CONTRACT NO. 1800

WET WEATHER PUMP STATION

ADDENDUM NO. 11

ALLEGHENY COUNTY SANITARY AUTHORITY
WASTEWATER TREATMENT PLANT
WET WEATHER PUMP STATION
430-AD-04
WINDOW AND LOUVER DETAILS

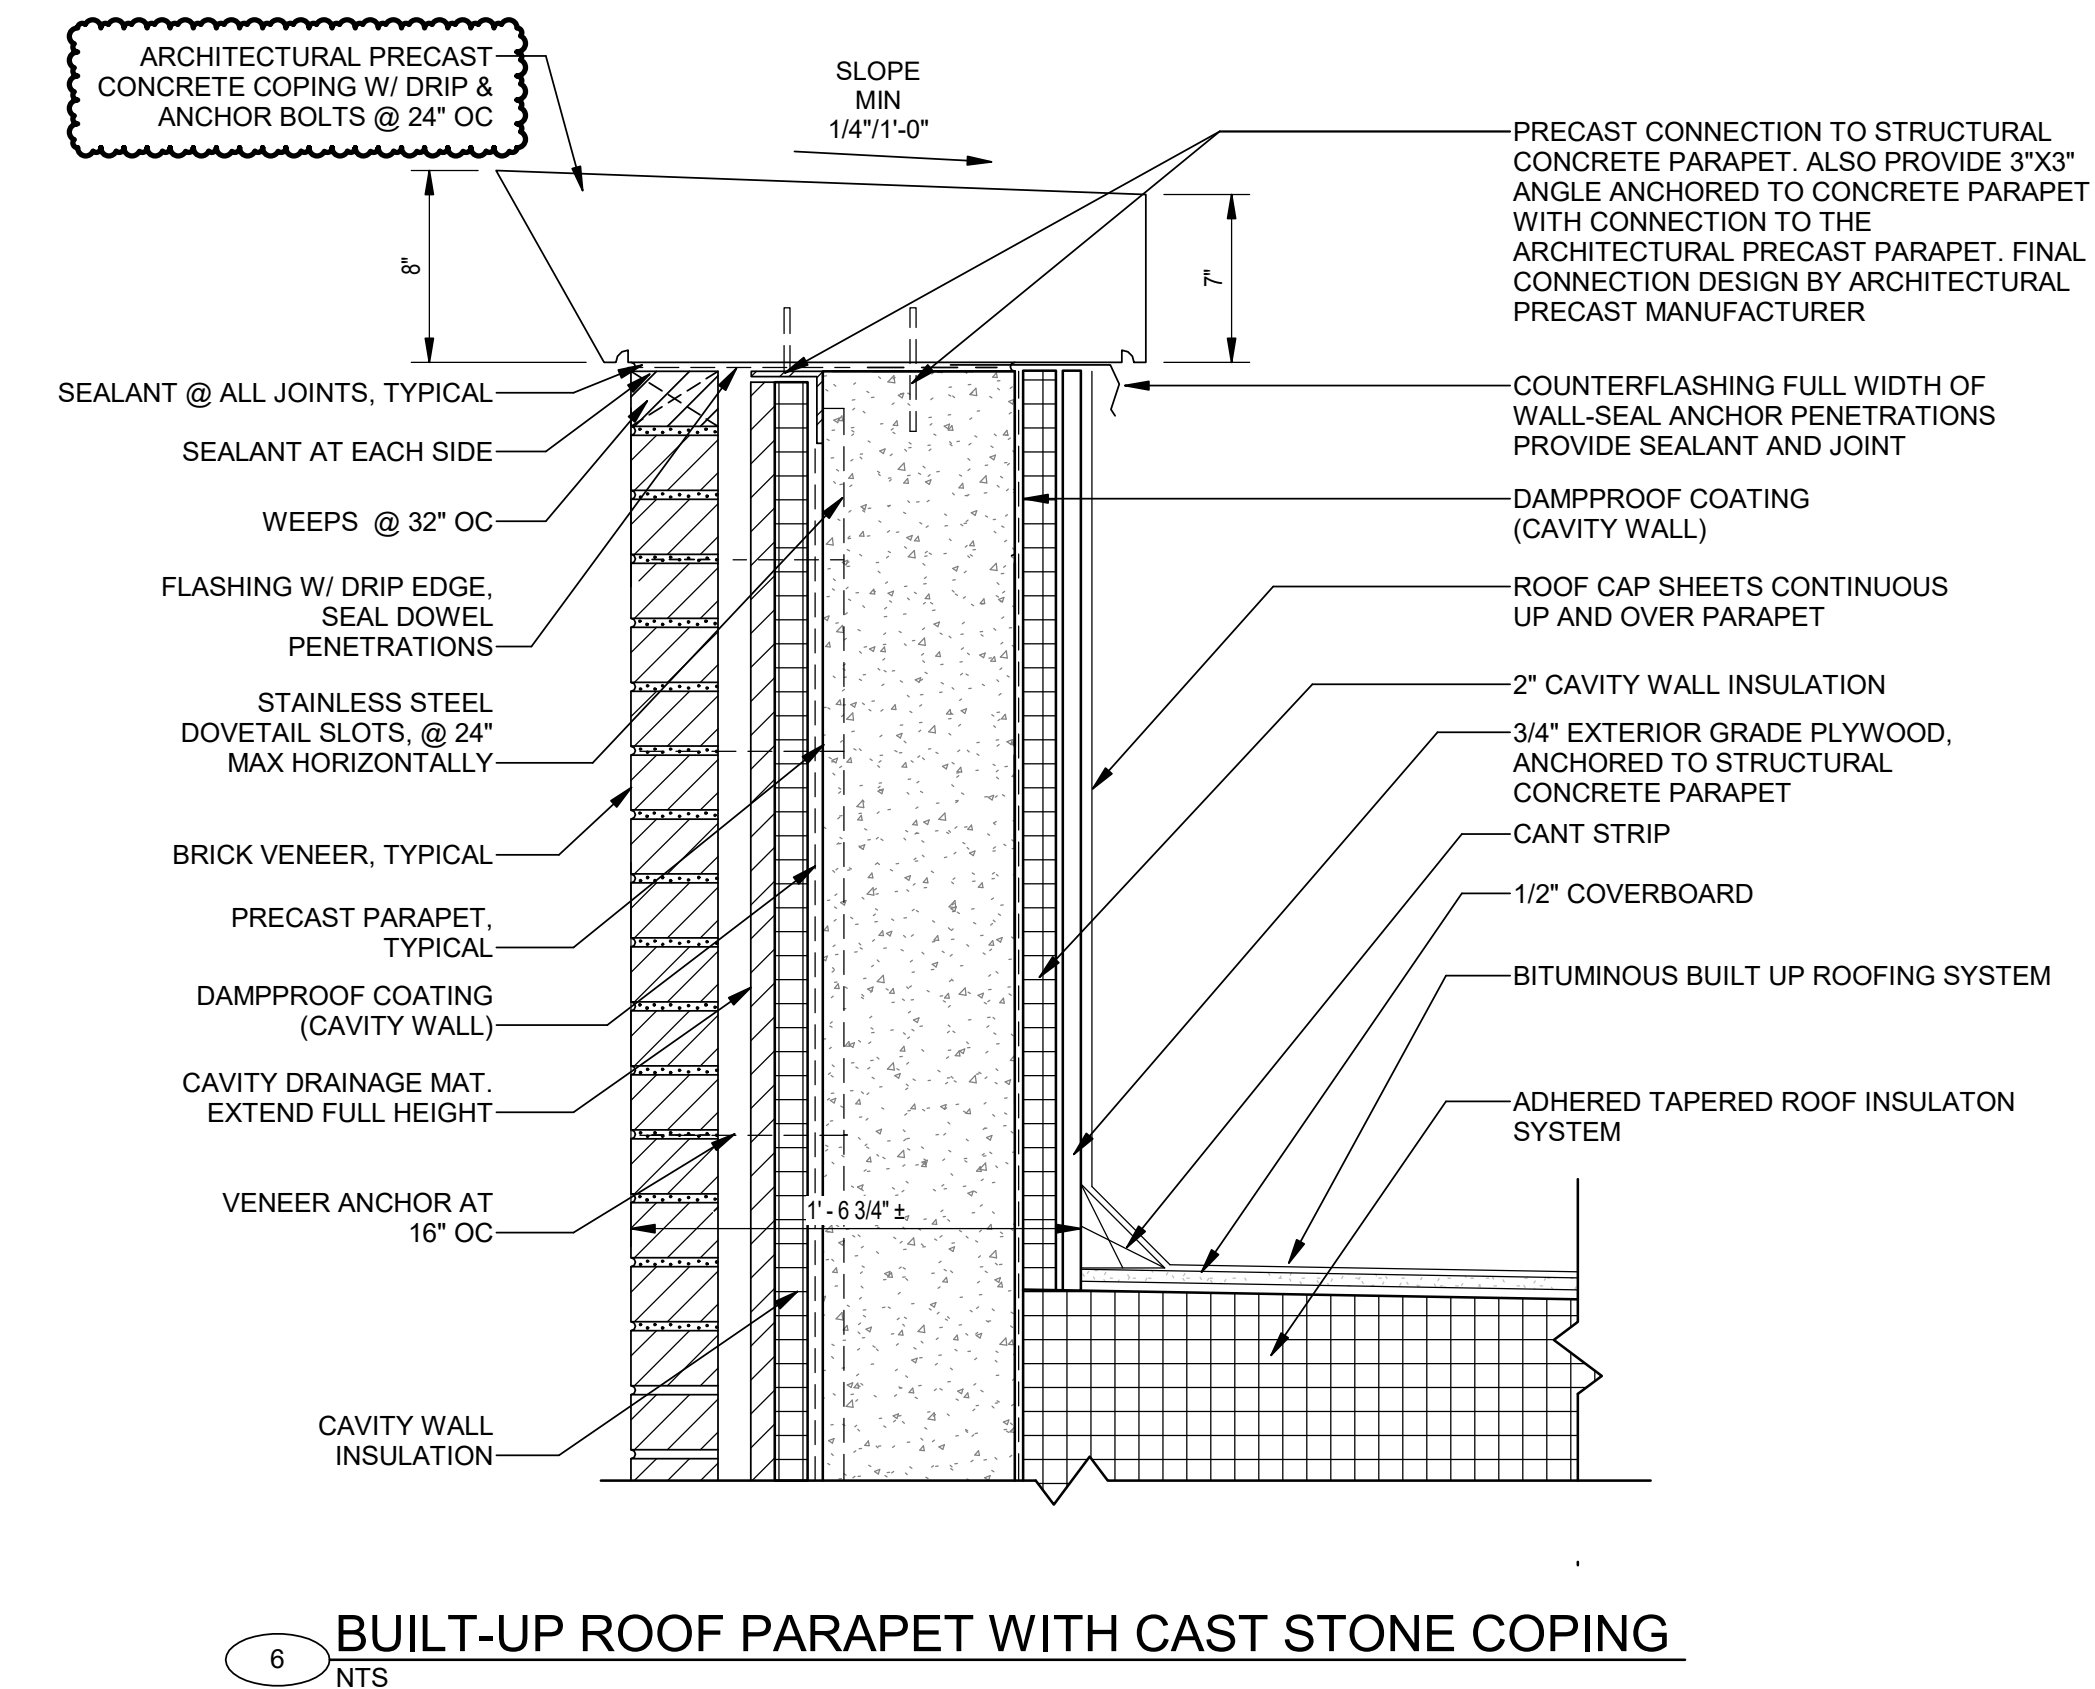
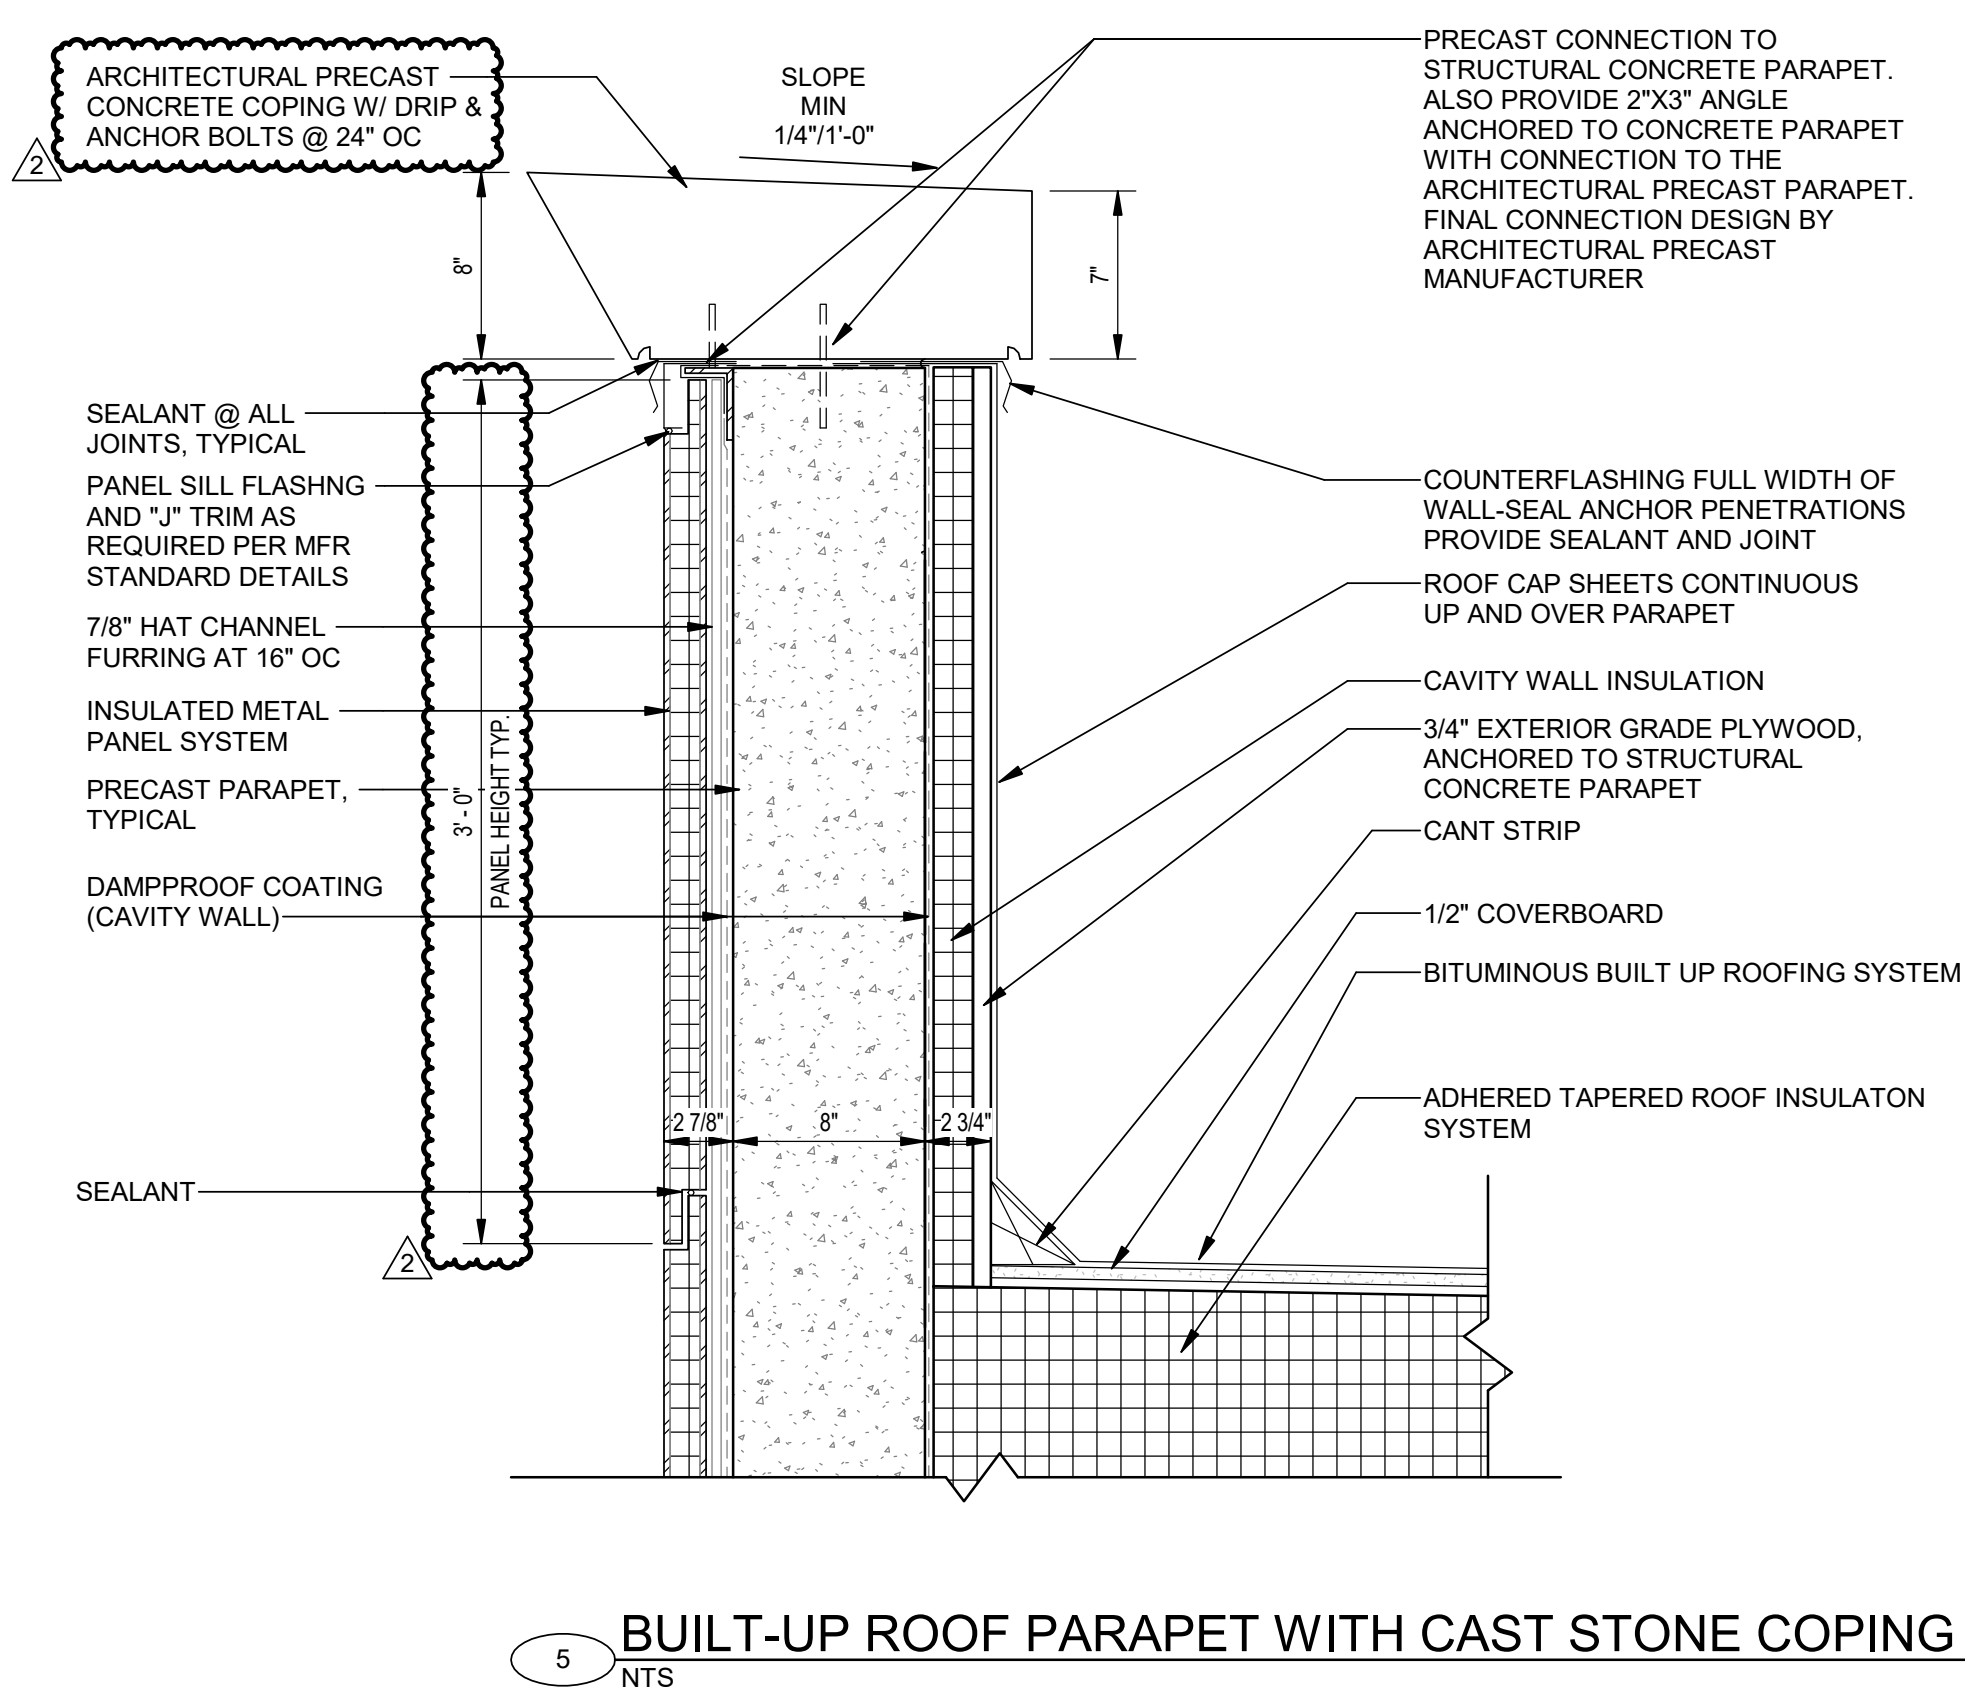
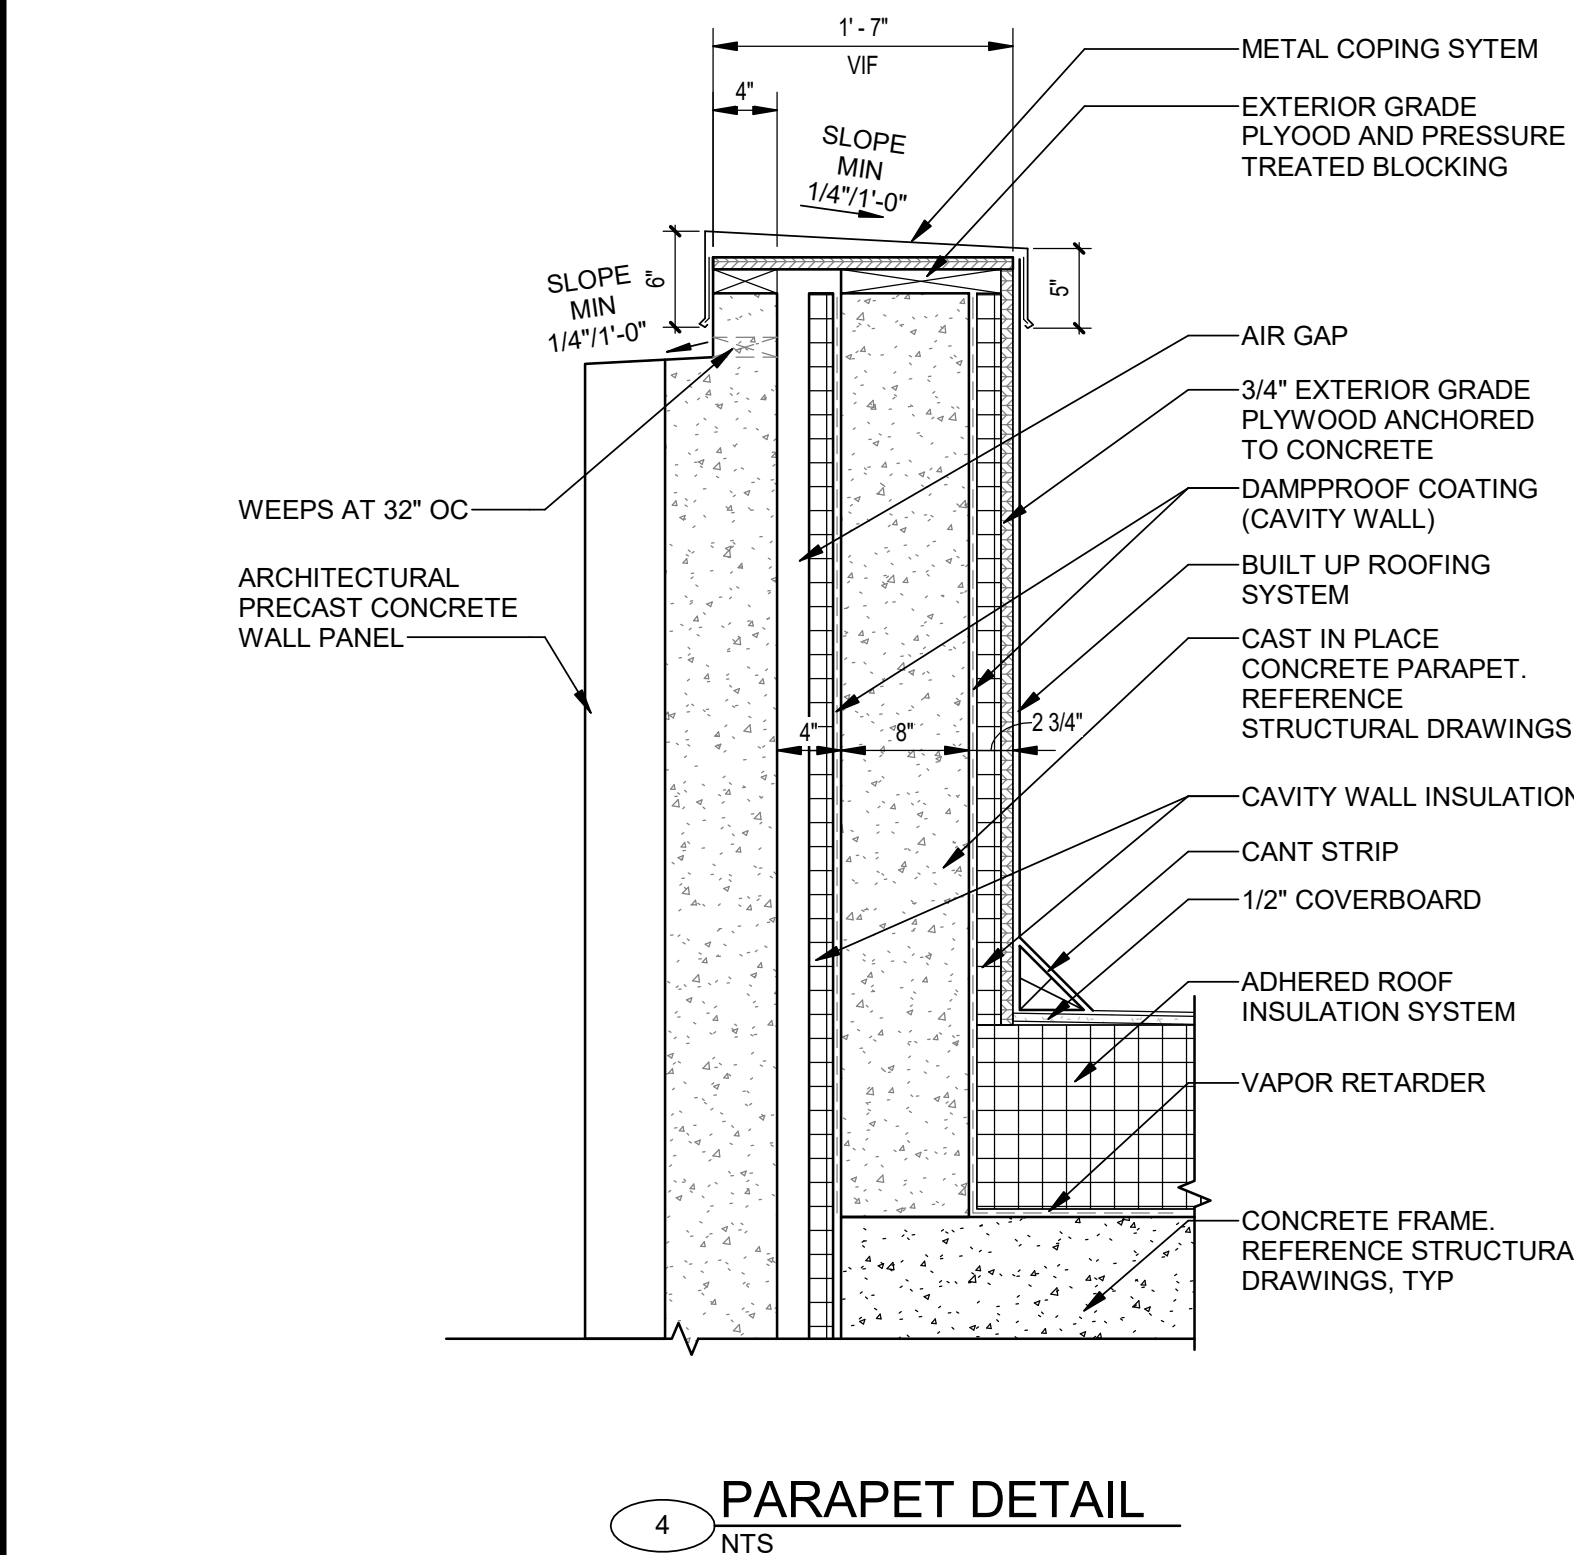
- Q34:** Detail 3/430-AD-04, 3/430-A-28 and 1/430-A-33, indicate the panel module width to be 2'-6". This however conflicts with the Specifications 2.03.1 which specifies the panel module to be 3'-0". Please clarify that the 2'-6" width in the Drawings is correct.

- A34:** The 3' Panel module noted in the specifications is the correct module. Refer to Items 4.10, 4.11, 4.12 and 4.13 of Addendum No. 11.
- Q35:** Drawing 430-AD-01 and numerous others shows the panel module thickness as 2". This however conflicts with the Specifications 2.03.4 which specifies the panel thickness to be 3" or to provide 4" when used in conjunction with Fire Resistant Wall Panels. Please clarify that the IMP panels, erected to masonry and/or concrete walls, are not intended to provide fire resistance and that the 2" panel thickness in the Drawings is correct.
